ADDENDUM NO. 4

TO: Contract Documents for Construction of Central Avenue Flood Control Improvements - A FEMA Funded Project - Oracle Project No. 1002549

This Addendum No. 4 modifies the base bid schedule and corrects and clarifies the plans and specifications. Changes to project plans on attached sheets are shown clouded.

I 26 6 TURF REINFORCEMENT MAT
STA 20+45.00 TO 21+25.00
N.T.S.

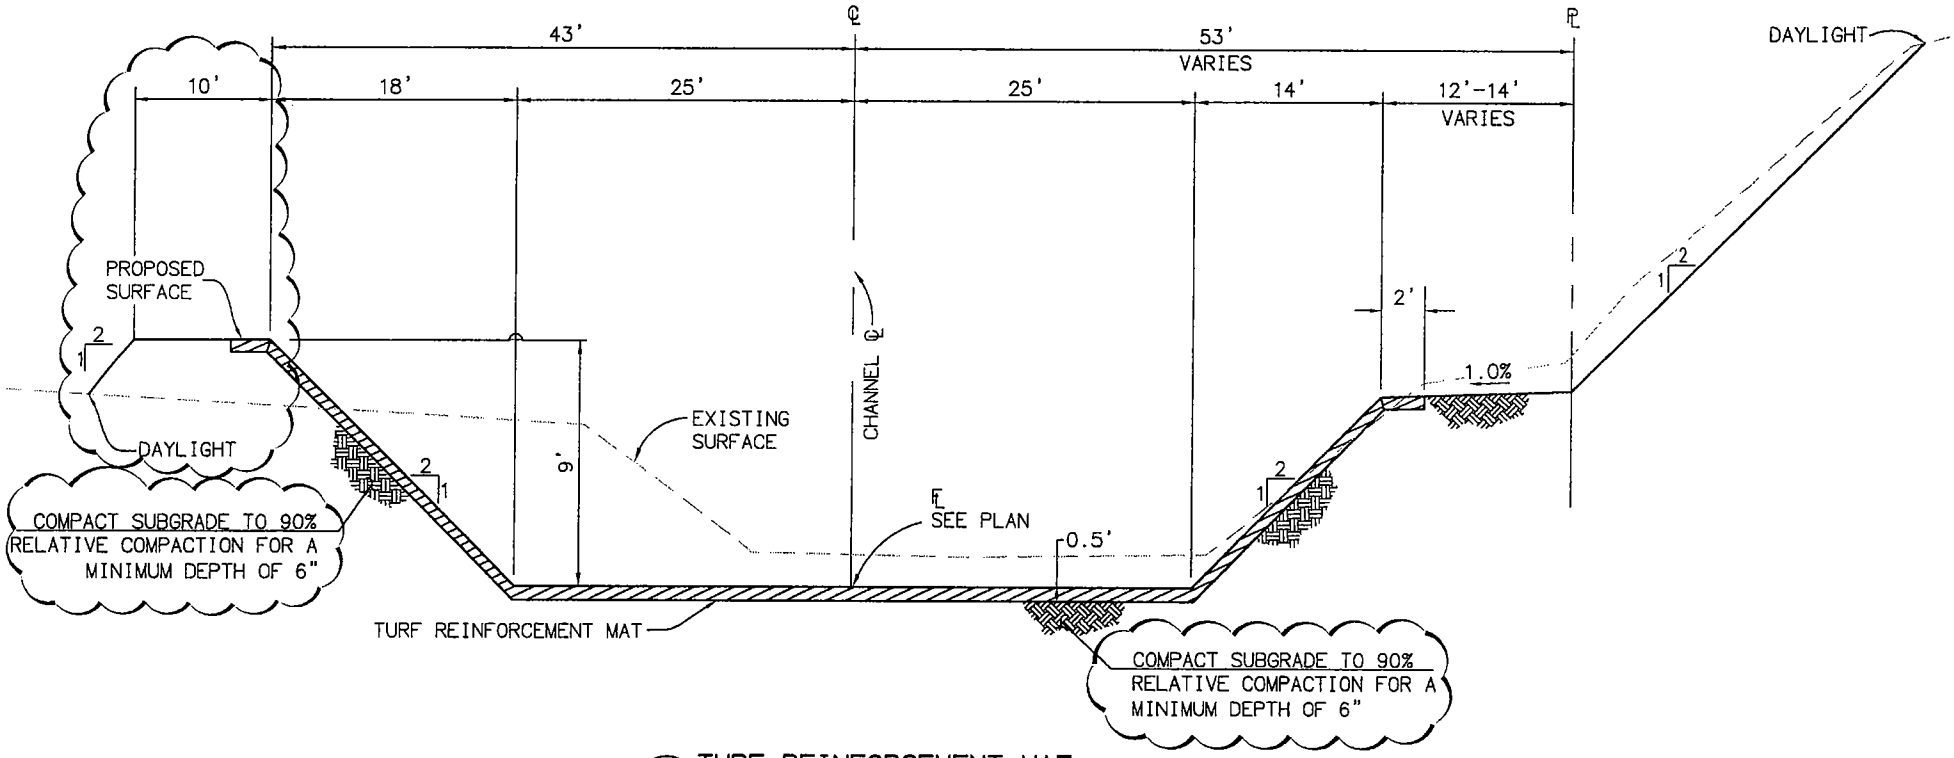
10. On sheet 6 of the project plans, replace Sections I, J and K with attached Sections I (Addendum No. 4), J (Addendum No. 4) and K (Addendum No. 4), respectively.

REVISED CROSS-SECTION FOR TURF REINFORCEMENT MAT ON SHEET 6

J 26 6 **CELLULAR BLOCK CHANNEL LINING SECTION**

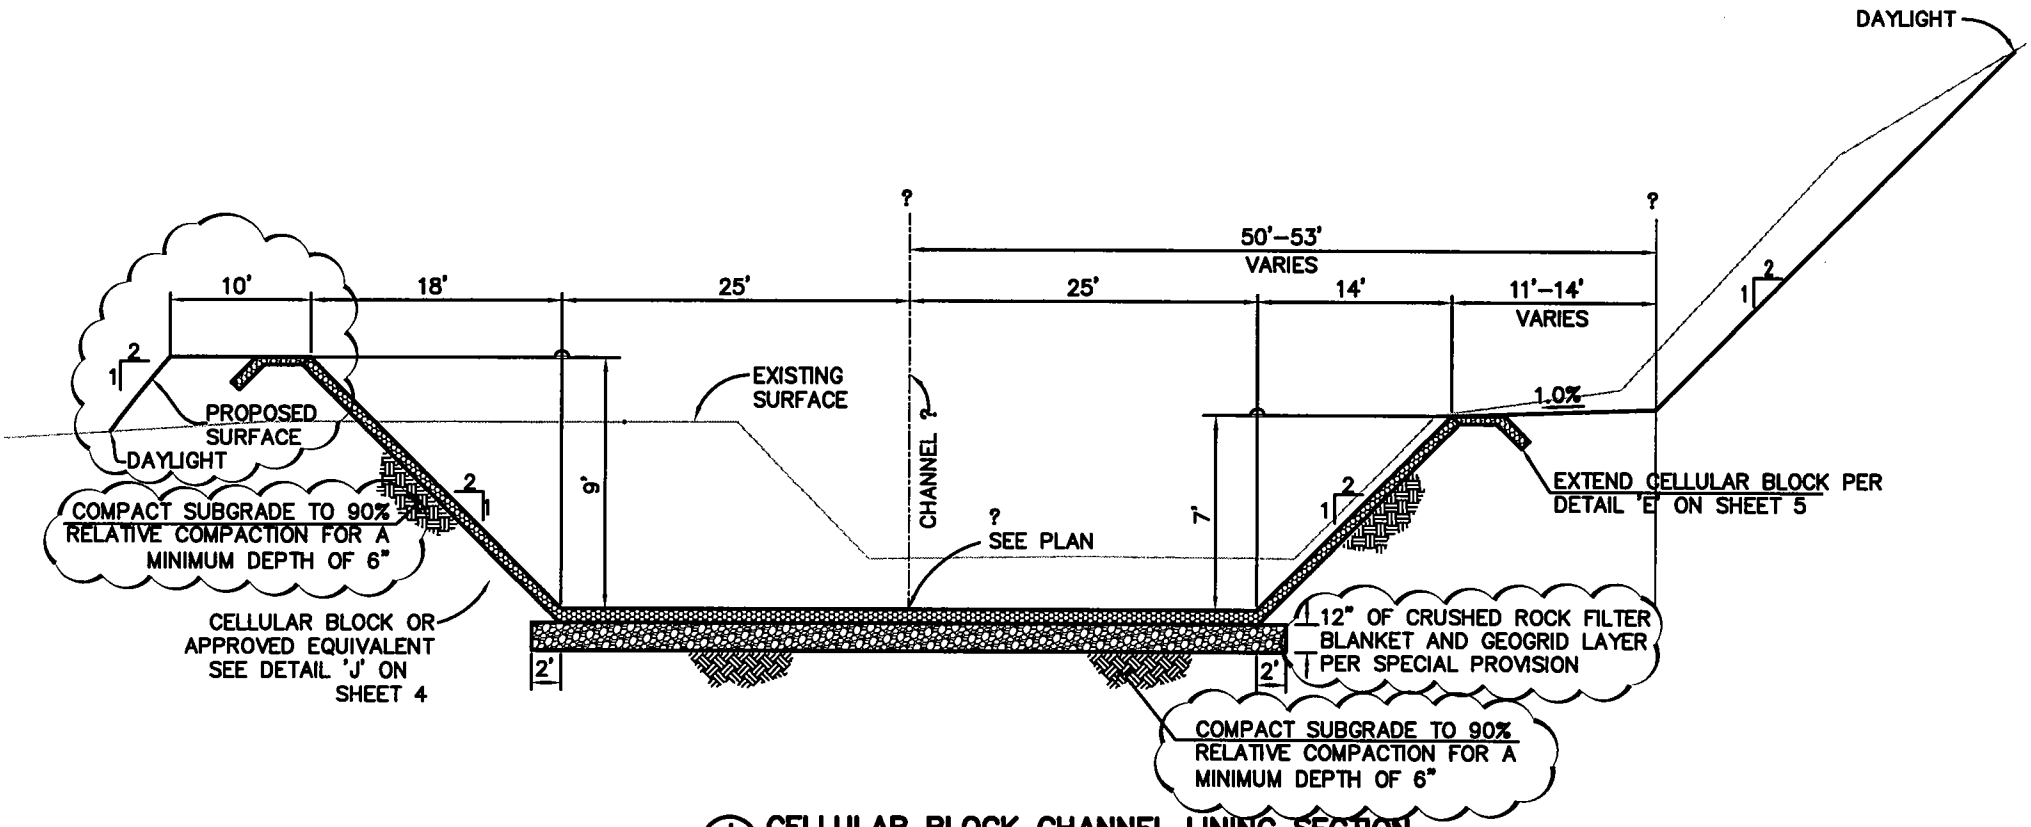
REVISED CROSS–SECTION FOR CELLULAR BLOCK CHANNEL LINING ON SHEET 6

K
26 6

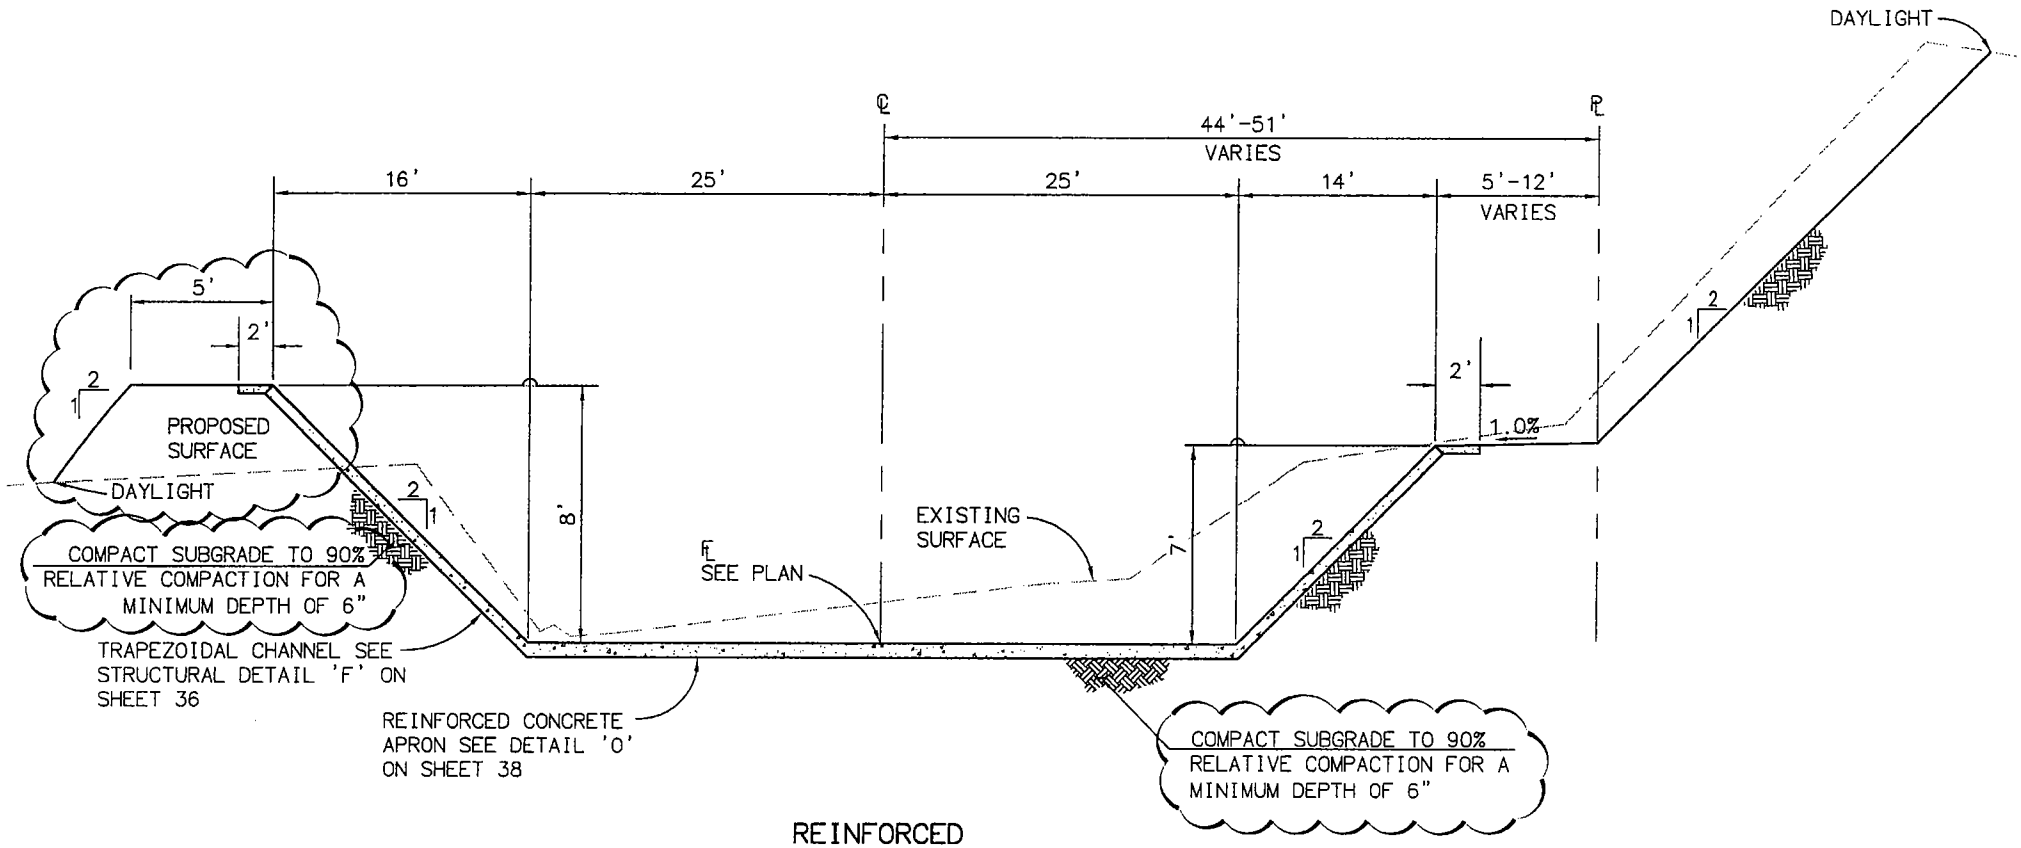
REVISED CROSS-SECTION FOR
CONCRETE APRON ON SHEET 6

M 26 7

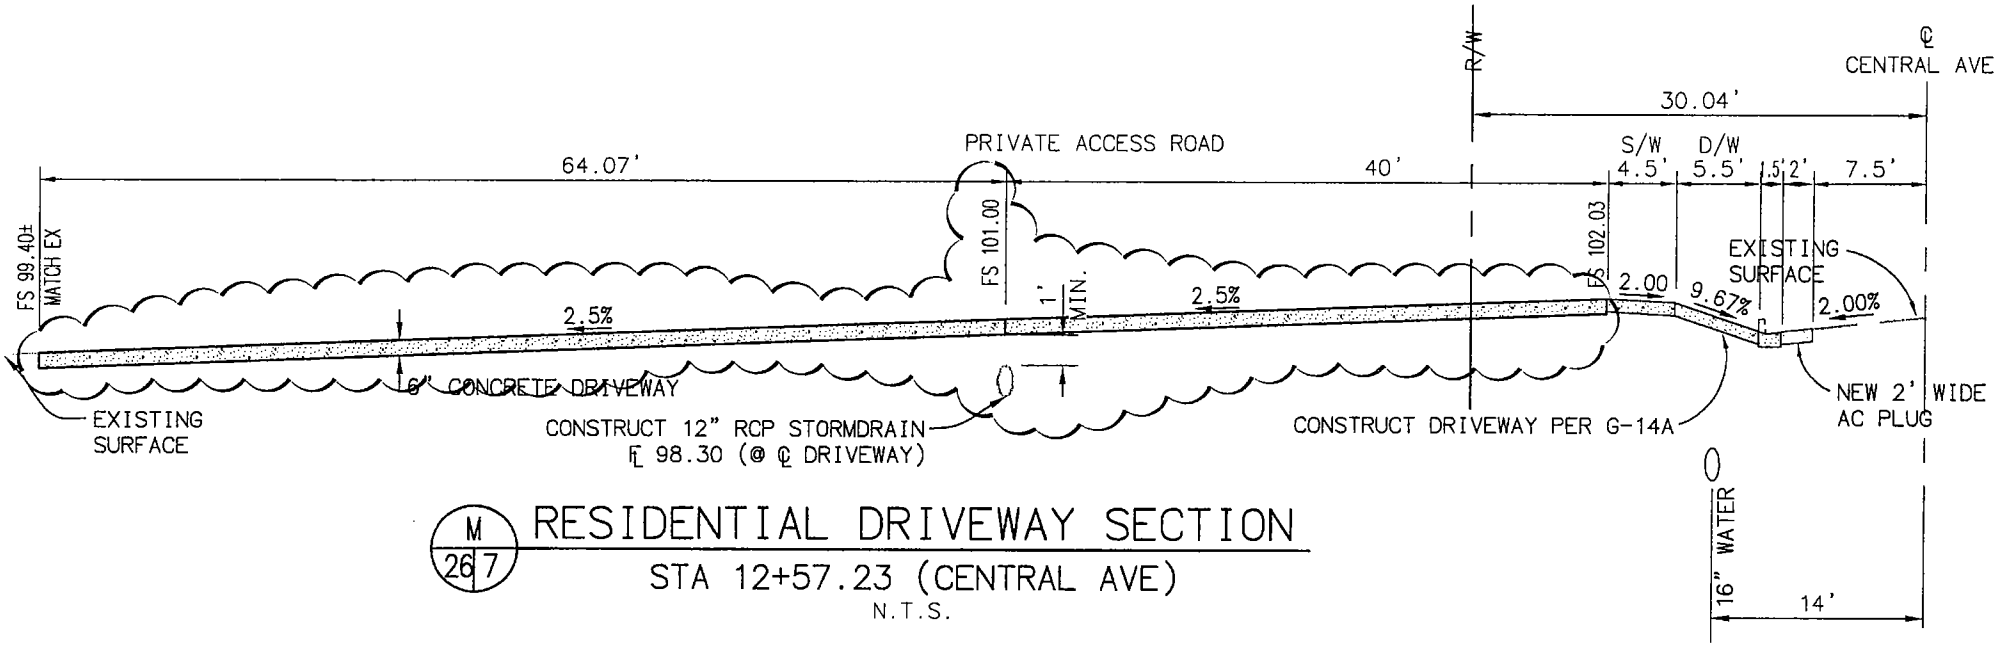
11. On sheet 7 of the project plans, replace Sections M, O, Q, R and S with attached Sections M (Addendum No. 4), O (Addendum No. 4), Q (Addendum No. 4), R (Addendum No. 4) and S (Addendum No. 4), respectively.

REVISED CROSS-SECTION FOR RESIDENTIAL DRIVEWAY ON SHEET 7

0
27/29

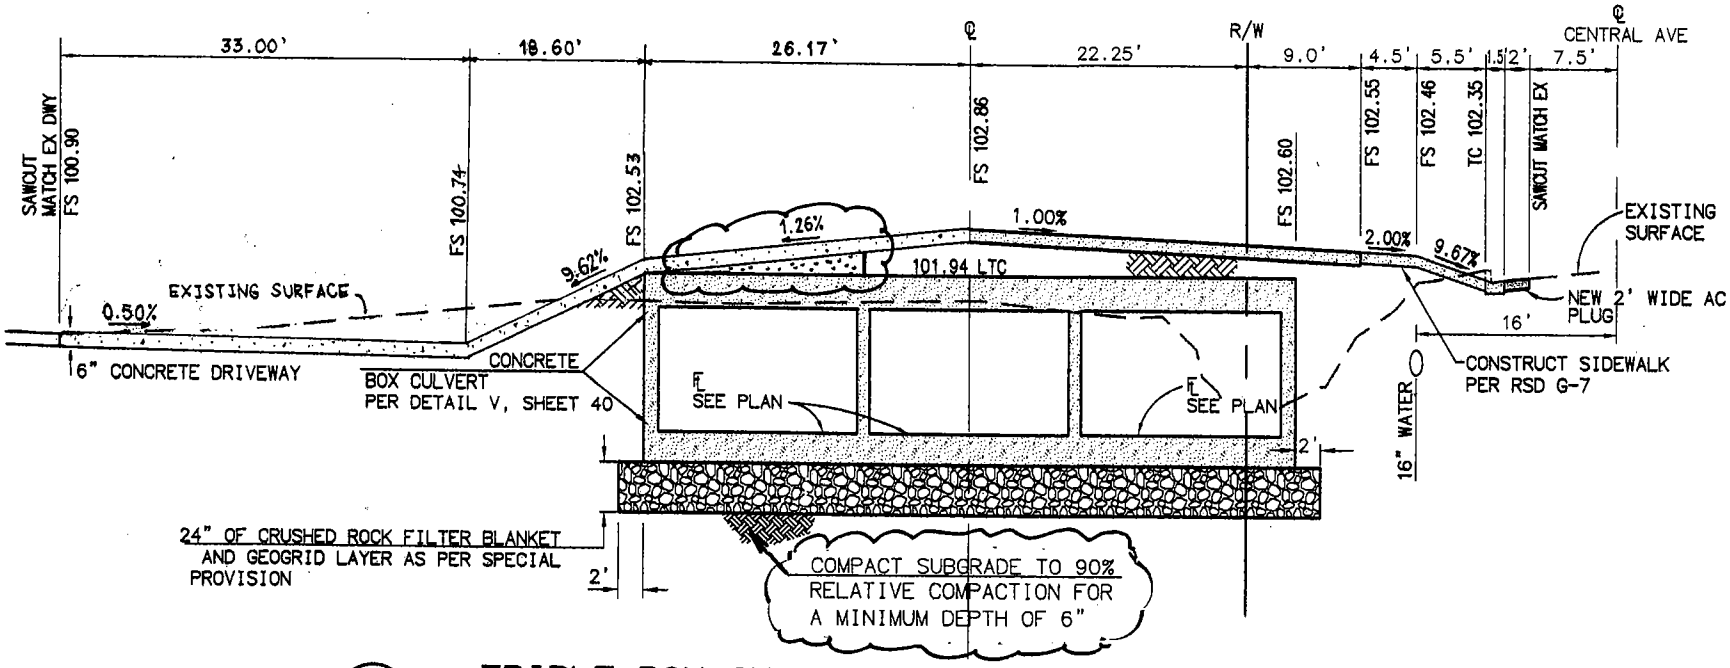
REVISED CROSS-SECTION FOR TRIPLE BOX CULVERT RESIDENTIAL DRIVEWAY (DETAIL "O") ON SHEET 7

Q 27/7

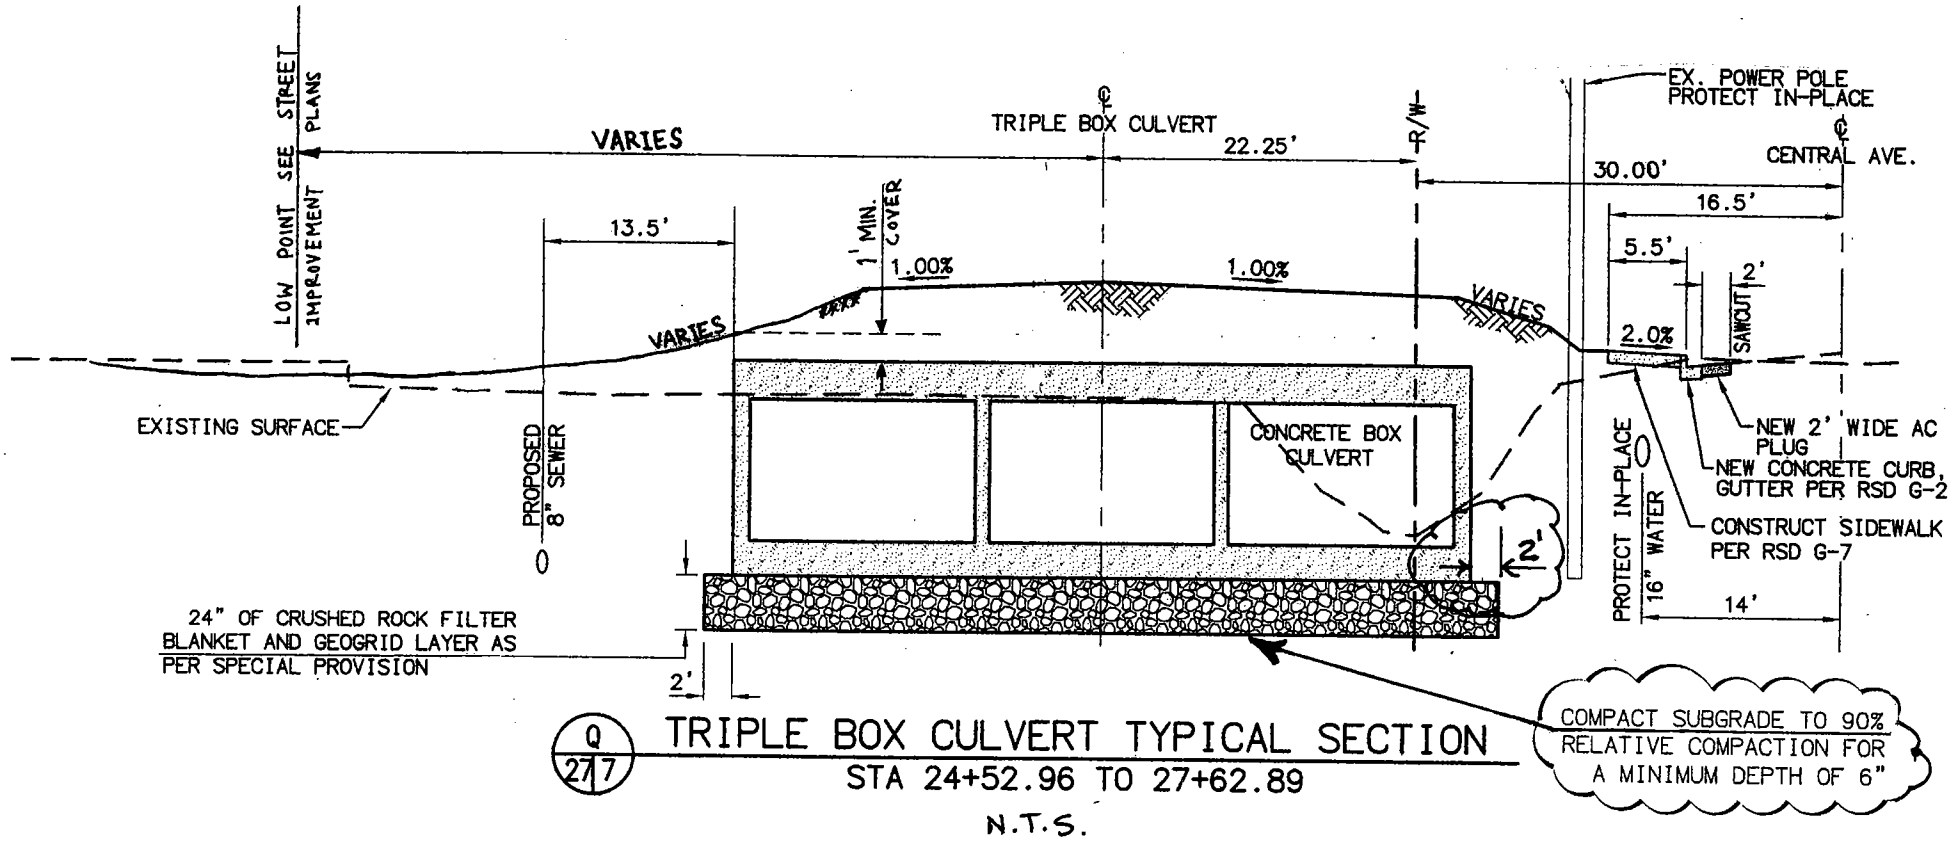
REVISED CROSS-SECTION FOR TRIPLE BOX CULVERT ON SHEET 7

R 27/29

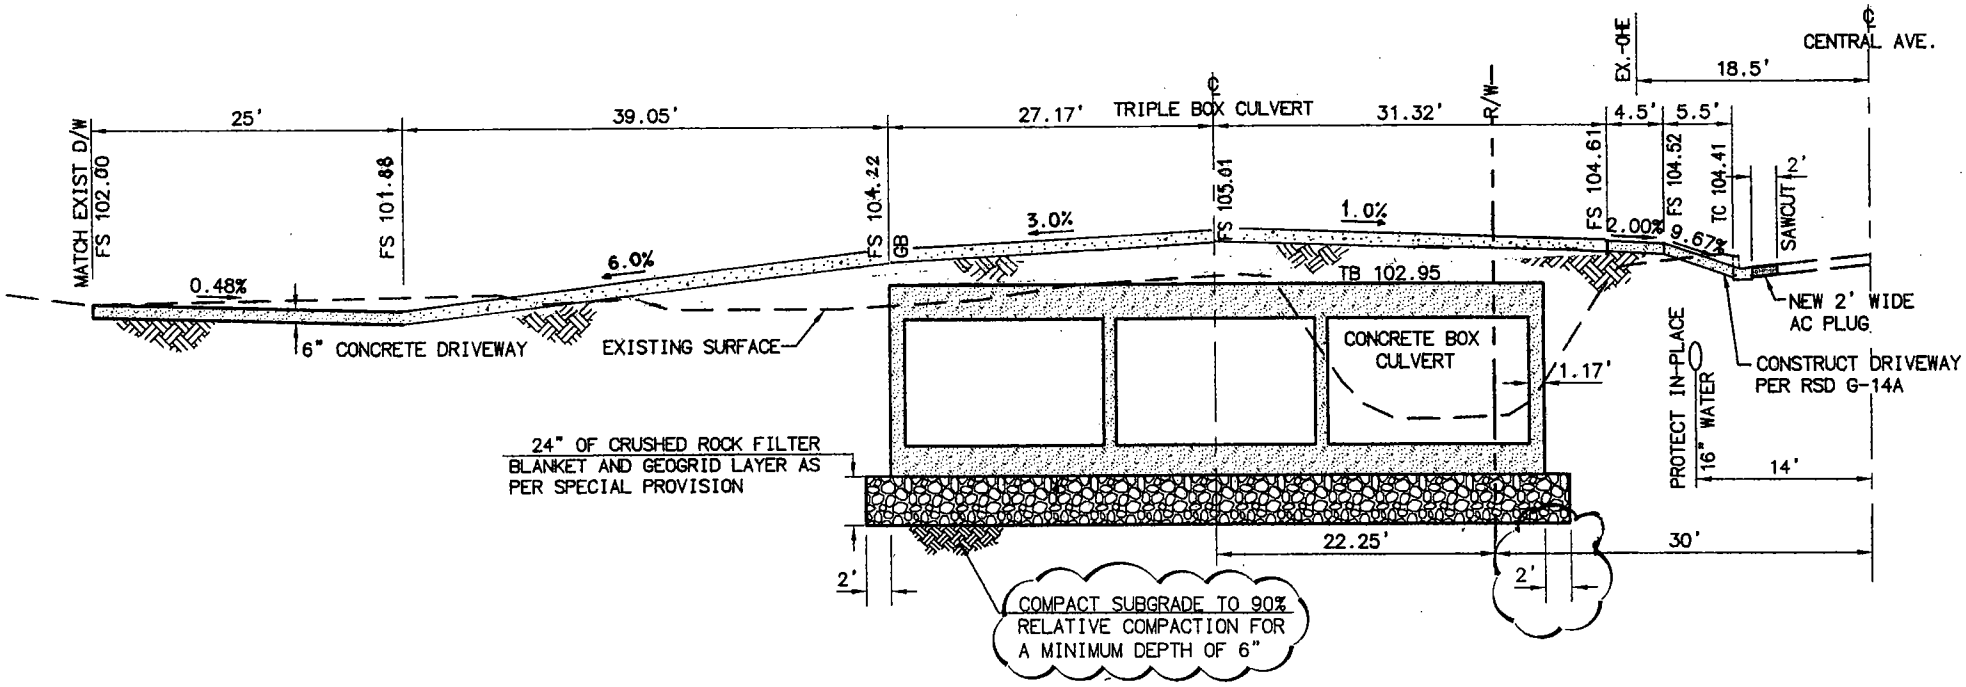
REVISED CROSS-SECTION FOR TRIPLE BOX CULVERT RESIDENTIAL DRIVEWAY (DETAIL "R") ON SHEET 7
